SERVICE BULLETIN

Fuel Line Replacement And Conversion

DATE May 28, 1956

SERVICE BULLETIN NO. 12

A. Mark 20H Operation

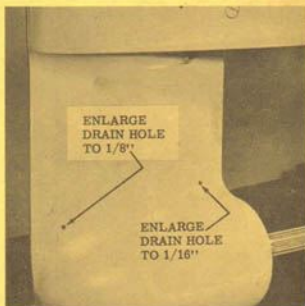
If a Mark 20H, equipped with a carburetor conversion kit, has a tendency to flood or "overload" when running in choppy water, it can be corrected by installing a 1399-1138 inlet needle and seat in the carburetor and replacing fuel pump cover 23008 (having two pressure holes) with fuel pump cover 29044 (having only one pressure hole). This reduces fuel pump pressure to the carburetor. Any tendency to run lean at part throttle in the turns can be corrected by enriching the low speed needle valve setting to approximately $2\frac{1}{2}$ turns open and by adding a spray shield in front of the carburetor.
